Department of Transportation

MEMORANDUM

SUBJECT: ZC Case No. 25-20 – 2455 Alabama Avenue SE (MPD 7th District Headquarters)

Figure 1 | Site Plan

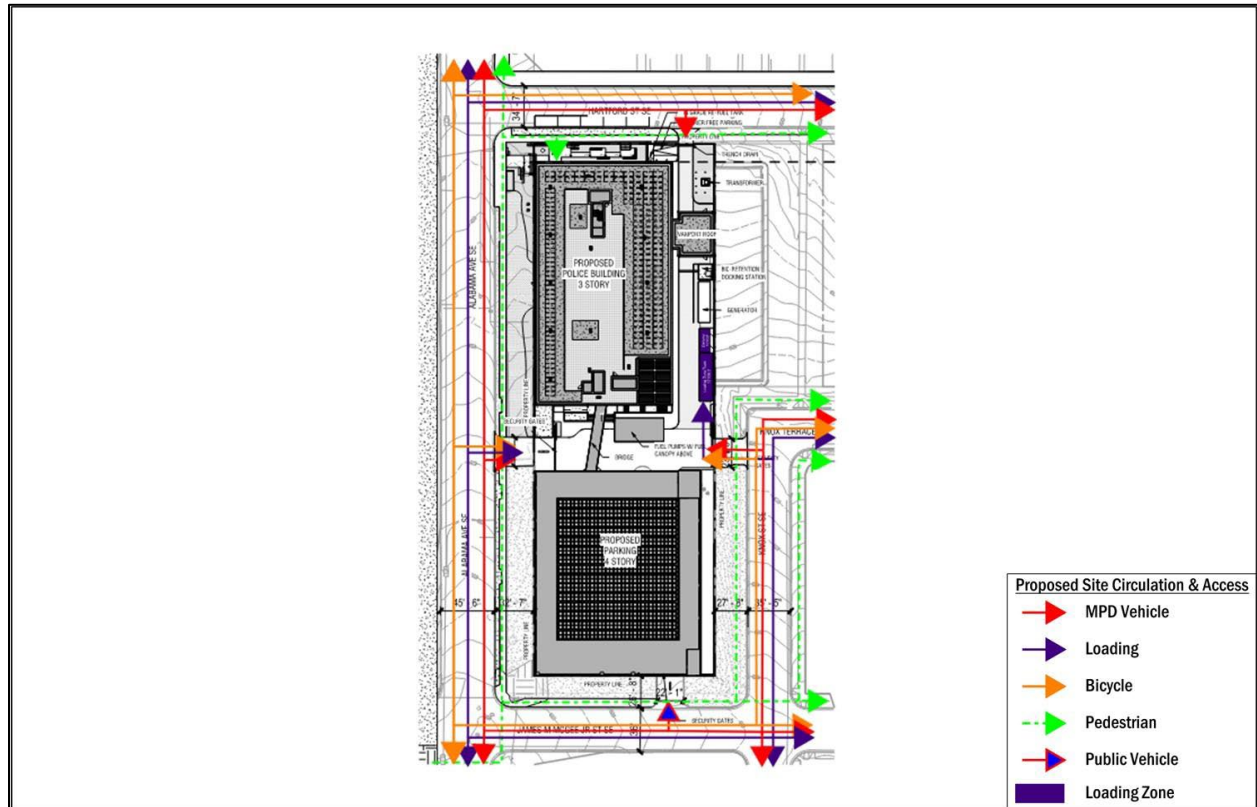
Pedestrian access will be provided from Alabama Avenue SE, with a new pedestrian bridge connecting the headquarters to the parking structure to reduce at-grade conflicts. The PUD will maintain vehicular access using the site’s four (4) existing curb cuts on Hartford Street SE, Knox Street SE, James M. McGee Jr. Street SE, and Alabama Avenue. Each curb cut will be upgraded to meet DDOT standards. The James M. McGee Jr. Street curb cut will be widened to accommodate two-way access into the public parking garage, and the Hartford Street curb cut will be reconfigured as enter-only to align with internal circulation. All loading, delivery, and fuel truck operations will occur internally to the site, accessed from Knox Street and Alabama Avenue.
